Technical Memorandum

Pages: 12
Ref: 17-000934.3015TM03.AM.rl

Subject: AURA Precinct 11 to 14 – Further Issues (3 Dec 2020) Response

This Technical Memorandum is to provide additional information following the EDQ Further Issues letter dated 3 December 2020 and Lot Layout Changes Request dated 30 November 2020.

Figure 2 – Intersection 70 SIDRA Modelling Layout

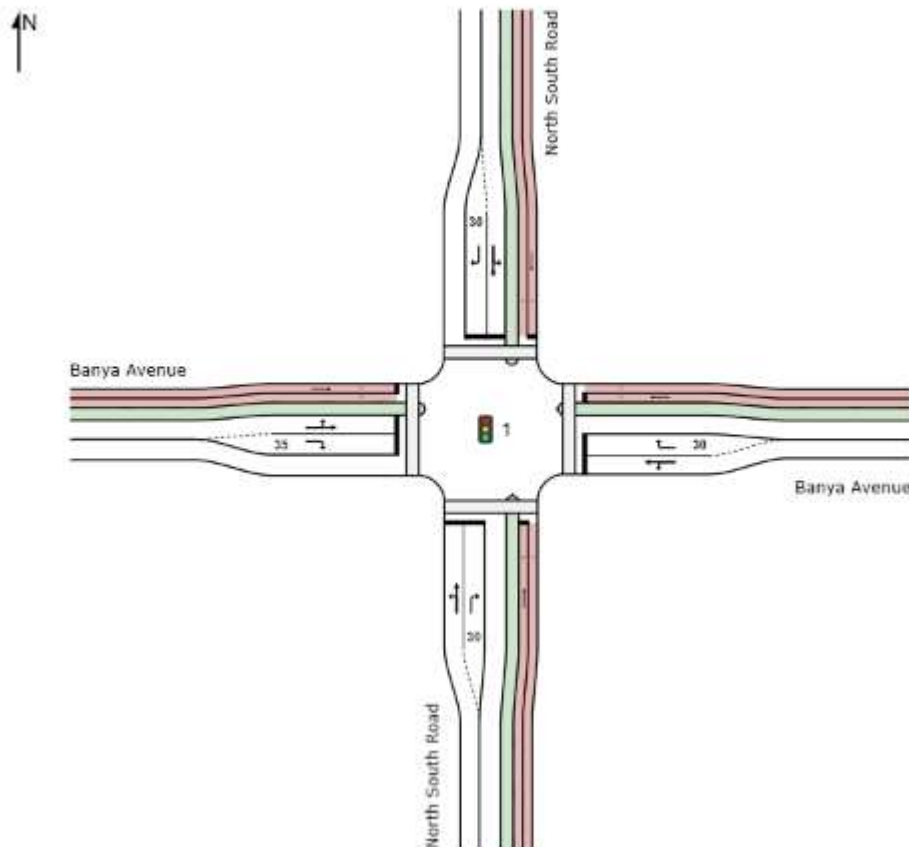
85. EDQ is concerned that the configuration of intersections that include off road contraflow cycle ways may not meet the prescribed levels of service when appropriate signal cycle times are implemented to achieve the required 20% modal share for cycling. Specifically, intersections that include left or right turning movements across contraflow cycleways, that have not been provided with dedicated left or right turn slots may not meet the prescribed levels of service or design warrants when signal cycle times provide priority to cyclists on the contraflow. Please provide sufficient detail that demonstrates that signal cycle times can be established that provide priority to cyclists on the contraflow (to support the requirement of the 20% modal share) and still meet the prescribed levels of service for all intersection vehicular movements. Include an assessment of any implications to intersection configuration including any additional dedicated right of left turn lanes required.

During detailed design all trunk road intersections are modelled with SIDRA to demonstrate all peak movement of vehicles, pedestrians and cyclists are accommodated in accordance with LGIA and Traffic Master Planning Requirements, which includes 20% modal shift to cycle movements. To provide an example of this process within this Development Application, one intersection has been modelled in SIDRA as a compliance example, presented below.

Please see the SIDRA output for the intersection 70, Figure 2 below. The followings are considered during SIDRA assessment:

- **SIDRA results:** SIDRA result shows that the intersection performance (both in AM and PM peak hour) is compliance to the LGIA requirements (volume on capacity ratio less or equal to 0.90). The summary of the results are:

- Level of Service: at least Level of Service D in all lanes and Level of Service D in pedestrian crossing
 - Volume on capacity ratio: less than 0.52 in all lanes

Figure 3 – Intersection 80

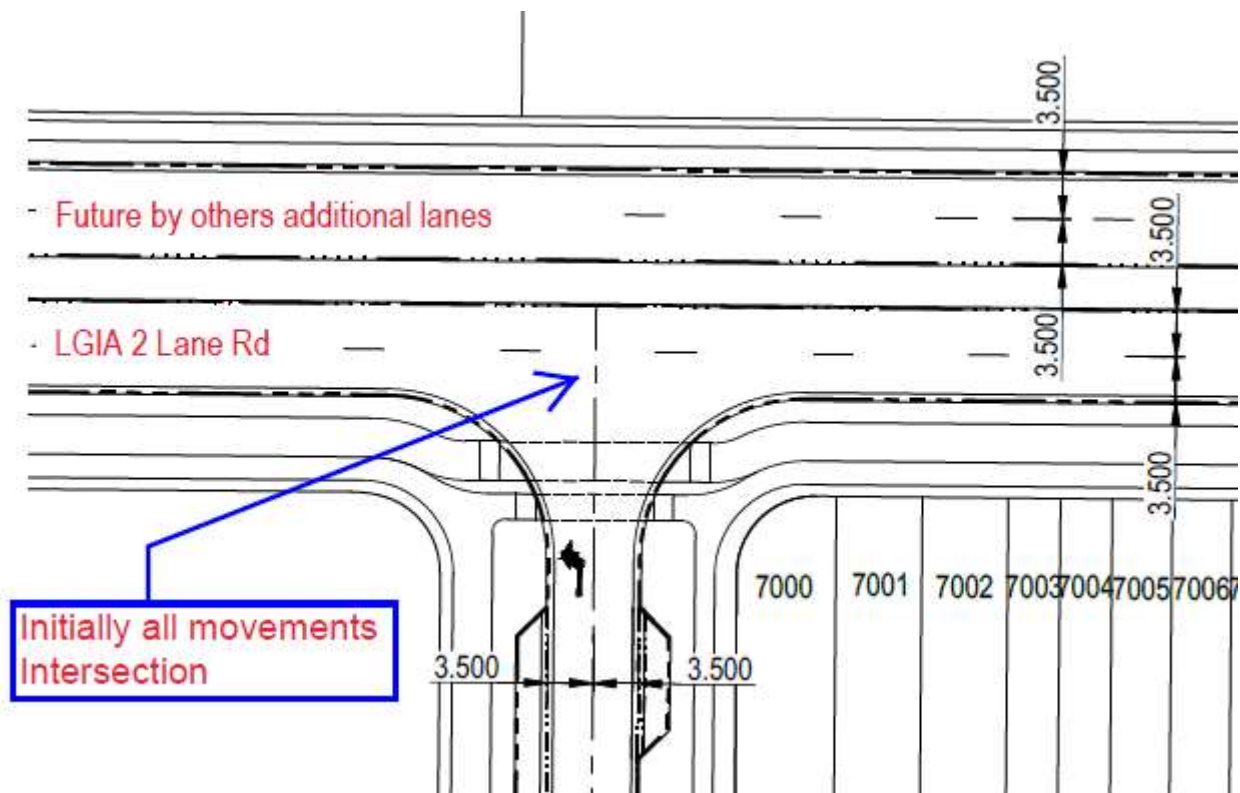
87. Intersection 80 is identified as an all turns T intersection in the PWC Refresh however the Calibre Functional Layout identifies this intersection as a left in left out only. This is considered to be a superior outcome, however, update the PWC report accordingly and confirm that restricting vehicle movement at intersection 80 does not have an adverse impact on other local intersections that now need to accommodate additional turning movements by traffic accessing the neighbourhood connector in Stages 1457-1452.

Stockland's obligation under the LGIA is only to construct this road to 2 lanes which will operate as per the PWC traffic model as an all movements intersection. The Calibre functional layout (17-000934.3015-DA657) demonstrates that a 4 lane sub-arterial can be accommodated within the provided road reserve (by others) which is assumed to be a LILO intersection. This will be subject to determination by others at a later stage. Figure 3 below indicates future the 4 lane sub-arterial intersection as per Calibre functional layout (17-000934.3015-DA657).

Figure 5 - 1D Network Layout (Selected Locations).

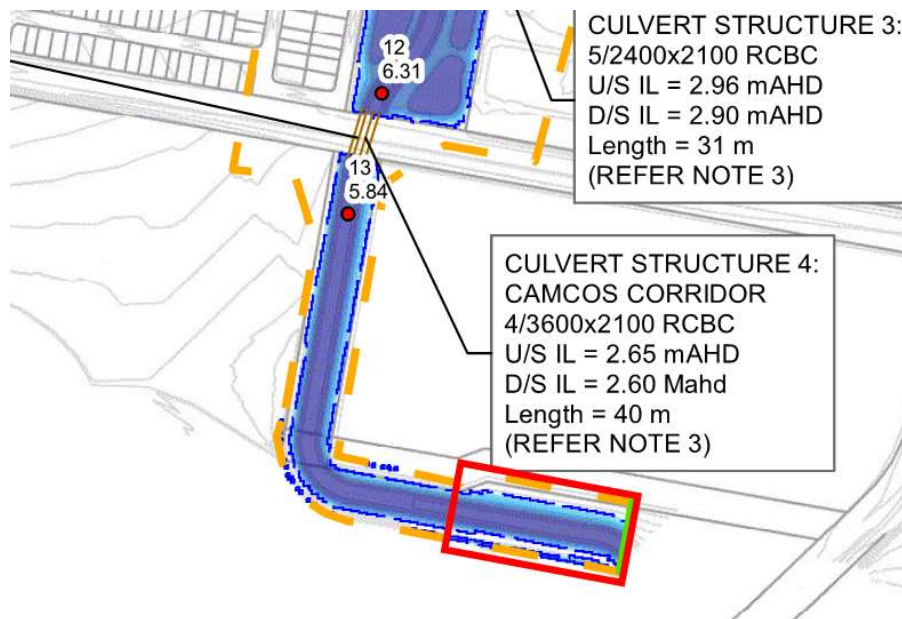
92. The DFE defined in this study for the properties in Aura Precinct 11 to Precinct 14 is based on peak water levels in Aura Brook only. High water levels from Bells Creek backing up into the brook should also be considered, i.e. the DFE should be defined as the higher of the local (Aura Brook) and regional (Bells Creek) flow.

Further to the above, the Figure 5 below is an extract of Calibre Drawing 18-000340-D-100CC-A has been provided. The area indicated in red box does require the adoption of the regional flood levels for the DFE.

INTERCHANGE
WITH 15m SHIFT
LAYOUT PLAN

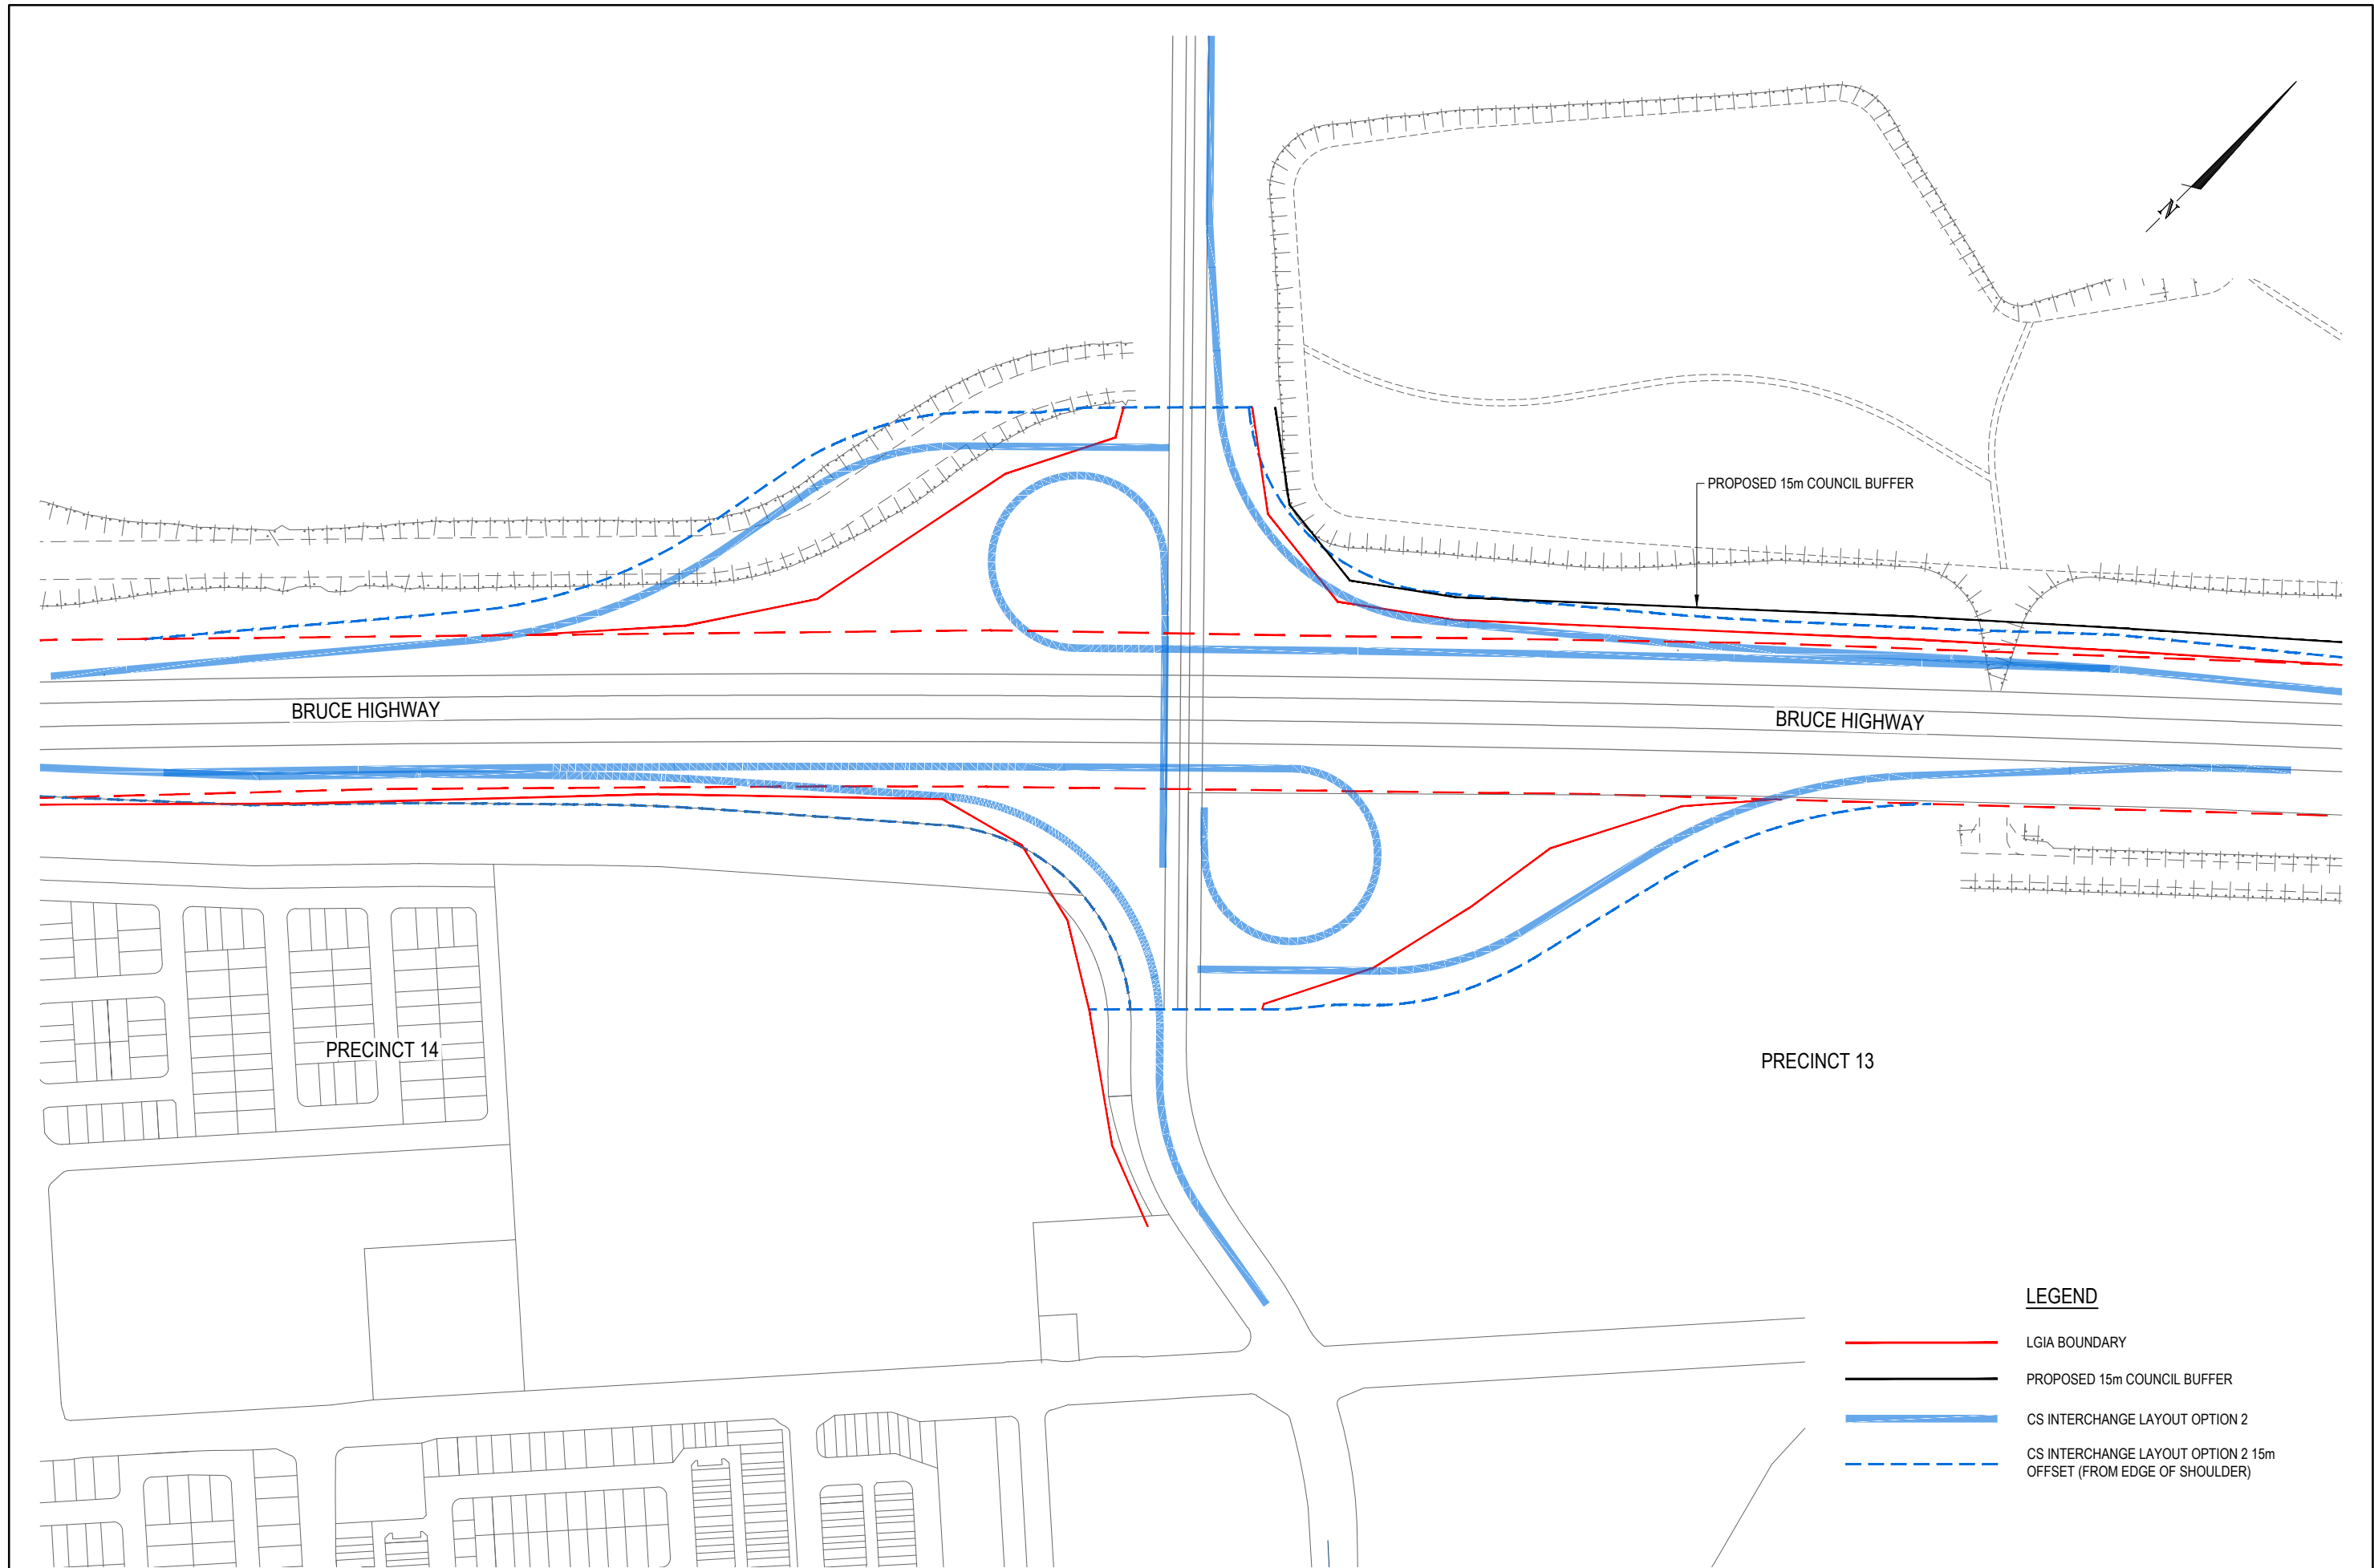
4. Provide amended plans that facilitates the footprint of the finalised interchange between the east west arterial and the Bruce Highway with evidence of support from DTMR.

Refer to Calibre Sketch plan 17-000934.3015-SK1002 Rev B (attached) for interchange layout plan. This layout has been used as the basis for the updated ROL plan included in the updated Plan of Development, dated December 2020, prepared by Urbis Liaison details with DTMR is provided in the overall Further Issues Response spreadsheet.
